RIGGING ADVISORY CIRCULAR

RAC No. 805 Rev. B

SUBJECT: MS70101 WARNING NOTICE

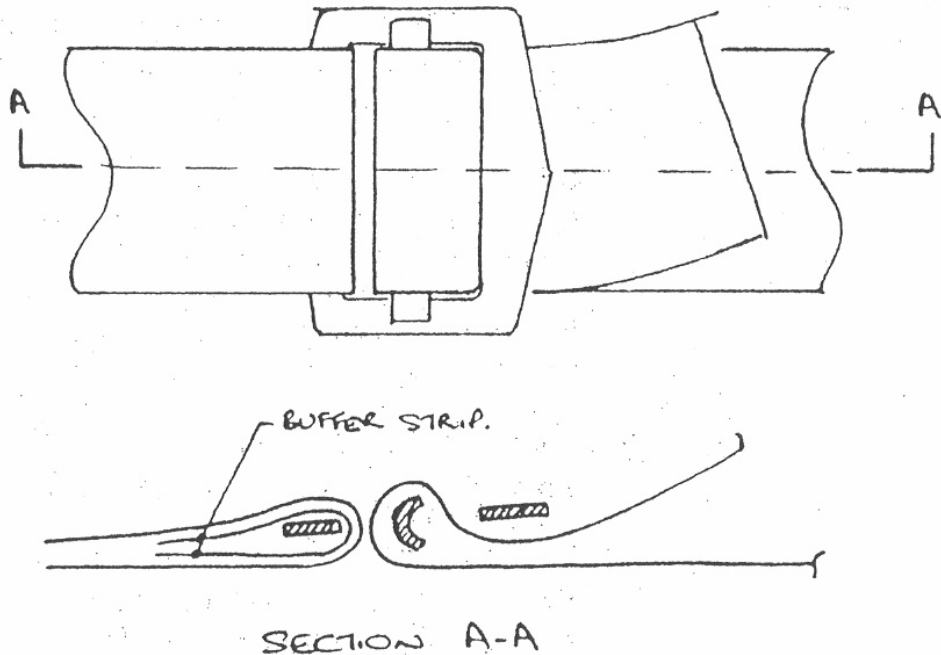
APF POLICY All dual parachute (Piggyback) harnesses which have a chest strap fitted with the MS70101 Lightweight Reversible Adaptor are to be inspected for the presence of a webbing buffer at the next periodic inspection and reserve repack.

If a webbing buffer is not present the packer 'A' is to incorporate a webbing buffer using a 25 mm (1') length of MIL-W-4088 type 12 webbing (or equivalent) tacked in place as illustrated below, or

alternatively where there is insufficient space to follow the simple procedure above, the manufacturer or Rigger 'B' must incorporate a webbing buffer into the webbing securing the Chest Strap Adaptor by unpicking the stitching securing the Chest Strap and afterwards fixing the adaptor in place by duplicating the original stitching.
